**Item No. 4** **Closing - part of Golspie Street, north of Neil Avenue, and Opening - cul-de-sac at the terminus of Golspie Street, south of Chelsea Avenue (Elmwood-East Kildonan Ward) File DAOC 1/2009**

# ADMINISTRATIVE REPORT

**ISSUE: DAOC 1/2009 – PROPOSED CLOSING OF PART OF GOLSPIE STREET, NORTH OF NEIL AVENUE AND PROPOSED OPENING OF A CUL-DE-SAC AT THE TERMINUS OF GOLSPIE STREET, SOUTH OF CHELSEA AVENUE**

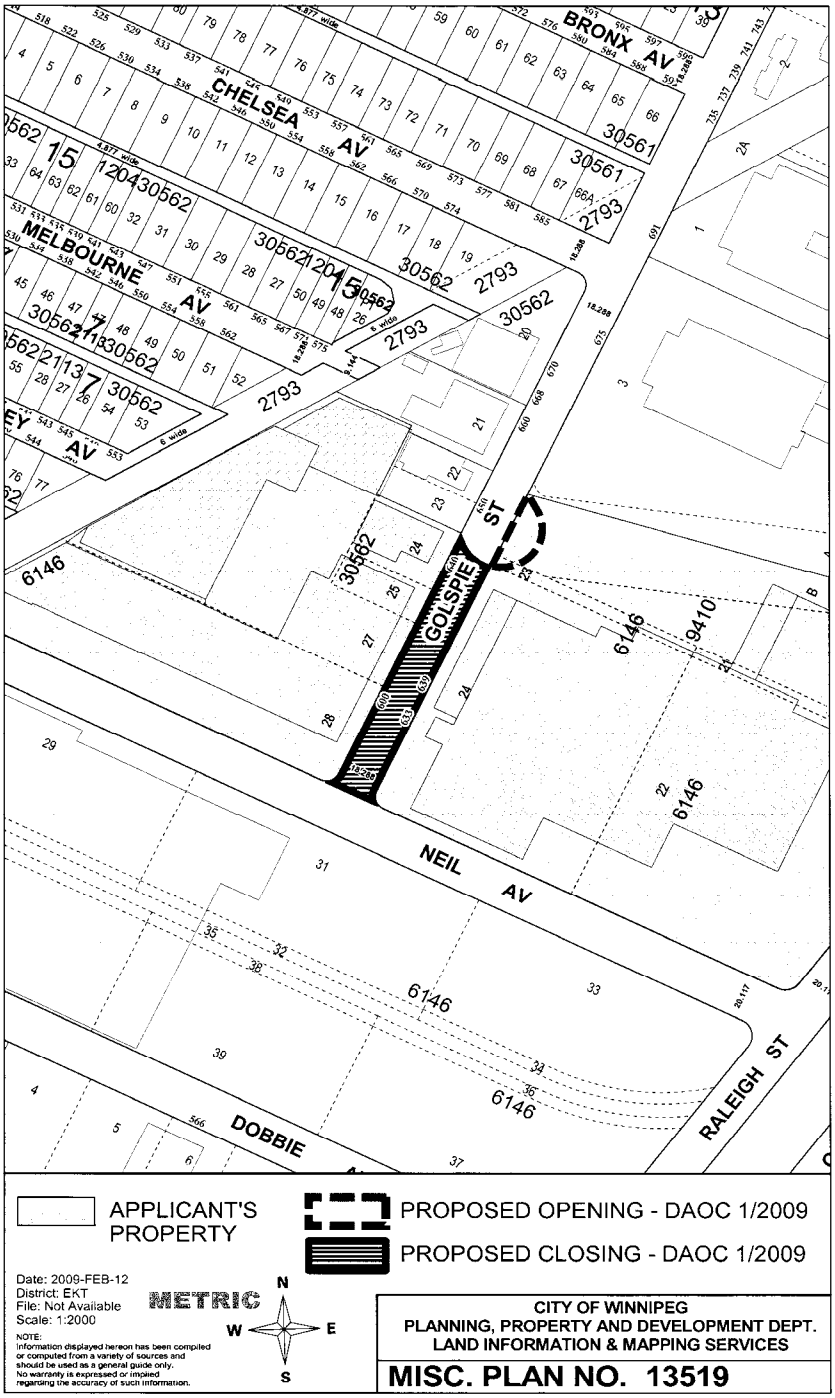
The applicant has recently submitted an application to demolish the building west of the proposed closing, being No. 600 Golspie Street. The Plan Examination Branch has no objections to the closing provided that the building is demolished. Should the building not be demolished, Plan Examination will not support this proposal because of potential building code contraventions. The Manitoba Building Code contains specific requirements that determine a building's code classification in relation to open streets. Building classifications respecting fire protection as determined by Subsection 3.2.2 and spatial separation requirements as determined by Subsection 3.2.3 have code requirements based on a structure's location in proximity to open rights of way. If the demolition is not proceeded with, the approval of the subject street closing may bring the applicant's building in direct contravention of the Manitoba Building Code with respect to both these subsections.

1) All truck traffic north of the closure would have to go through a residential area instead of coming off a truck route (Munroe Avenue) as it currently does.

2) Neil Avenue from Golspie Street to Raleigh Street is granular with very poor drainage which would not withstand the extra traffic from the closure of Golspie Street at Neil Avenue. The street would have to be upgraded to at least the same standard as Golspie Street west of Neil Avenue, complete with land drainage sewer.

3) The north side of Neil Avenue drains around the corner north on Golspie Street to the first set of catchbasins. Additional catchbasins would be required to be installed on Neil Avenue at the proposed street closure.

4) It appears that the location identified for the proposed cul-de-sac has a fire hydrant that would have to be relocated. The proposed cul-de-sac would have to be to an industrial standard, right-of-way, geometrics and construction standards.

Manitoba Hydro, Centra Gas and MTS Allstream have identified services within the closing area.
The Water and Waste Department has identified a 900mm sewer main and a 250mm water main within the subject closing which requires accessibility 24/7 in the event of servicing.

All utilities will require easements over the entire closing. No permanent structures of any kind will be allowed within these easement areas.

The approval of this application by the Transportation Engineering Division is subject to the following: the applicant will be required to enter into a Servicing Agreement to carry out the works identified in 2), 3) and 4) above, as determined by and to the satisfaction of the Director of Public Works.

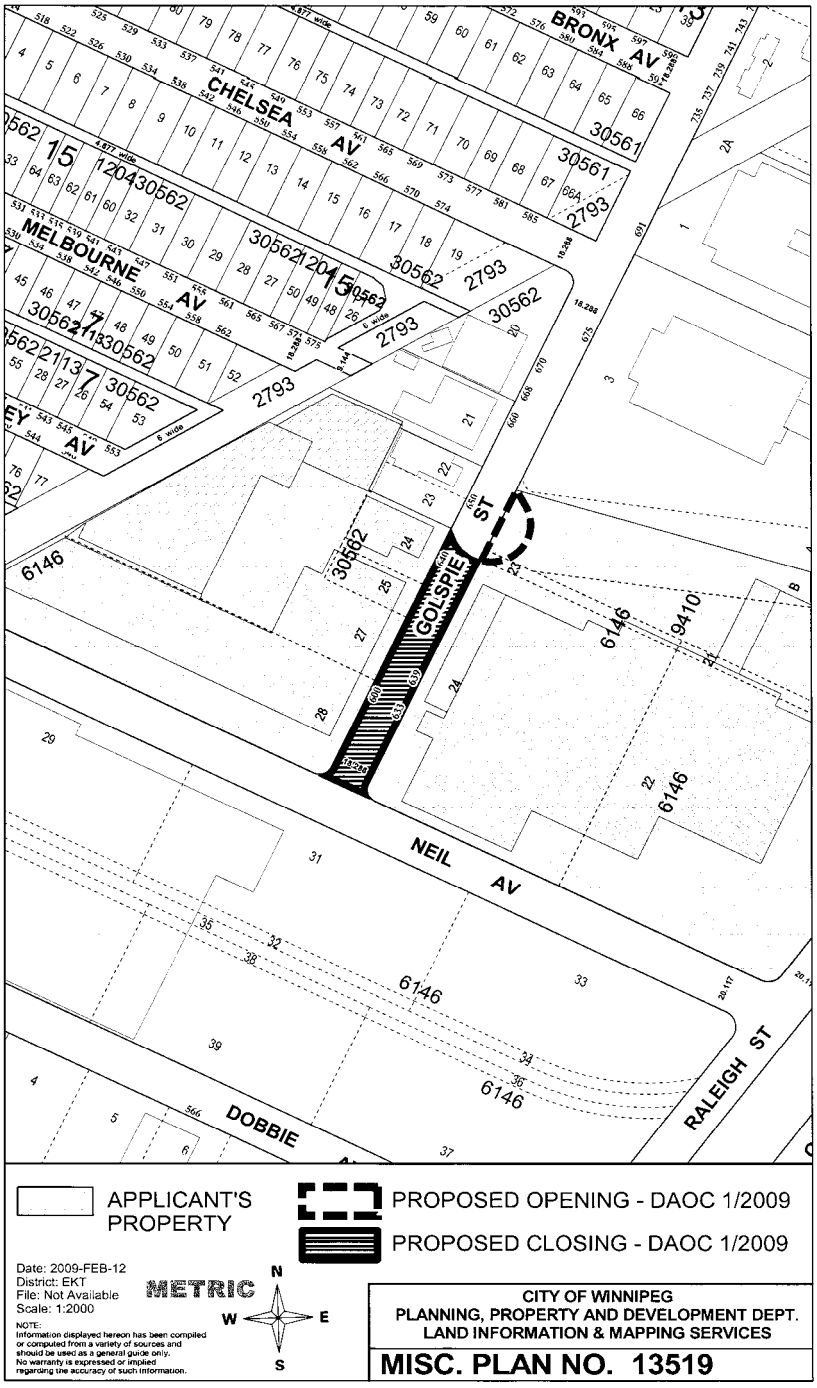
Fire and Paramedic Services does not support this proposal. Fire Station No. 8 is located at the corner of Kimerley Avenue and Golspie Street. Emergency vehicles require Golspie as an access route to areas south of the fire hall.

The applicant has recently submitted an application to demolish the building west of the proposed closing, being No. 600 Golspie Street. The Plan Examination Branch has no objections to the closing provided that the building is demolished. Should the building not be demolished, Plan Examination will not support this proposal because of potential building code contraventions. The Manitoba Building Code contains specific requirements that determine a building's code classification in relation to open streets. Building classifications respecting fire protection as determined by Subsection 3.2.2 and spatial separation requirements as determined by Subsection 3.2.3 have code requirements based on a structure's location in proximity to open rights of way. If the demolition is not proceeded with, the approval of the subject street closing may bring the applicant's building in direct contravention of the Manitoba Building Code with respect to both these subsections.

1) All truck traffic north of the closure would have to go through a residential area instead of coming off a truck route (Munroe Avenue) as it currently does.

2) Neil Avenue from Golspie Street to Raleigh Street is granular with very poor drainage which would not withstand the extra traffic from the closure of Golspie Street at Neil Avenue. The

street would have to be upgraded to at least the same standard as Golspie Street west of Neil Avenue, complete with land drainage sewer.

3) The north side of Neil Avenue drains around the corner north on Golspie Street to the first set of catchbasins. Additional catchbasins would be required to be installed on Neil Avenue at the proposed street closure.

4) It appears that the location identified for the proposed cul-de-sac has a fire hydrant that would have to be relocated. The proposed cul-de-sac would have to be to an industrial standard, right-of-way, geometrics and construction standards.

Manitoba Hydro, Centra Gas and MTS Allstream have identified services within the closing area.
The Water and Waste Department has identified a 900mm sewer main and a 250mm water main within the subject closing which requires accessibility 24/7 in the event of servicing.

Should this application be approved, all utilities require easements over the entire closing. No permanent structures of any kind would be allowed within these easement areas.

Should it be the decision of Council to approve the proposed opening and closing, the applicant would be required to enter into a Servicing Agreement to carry out the works identified in 2), 3) and 4) above, as determined by and to the satisfaction of the Director of Public Works.
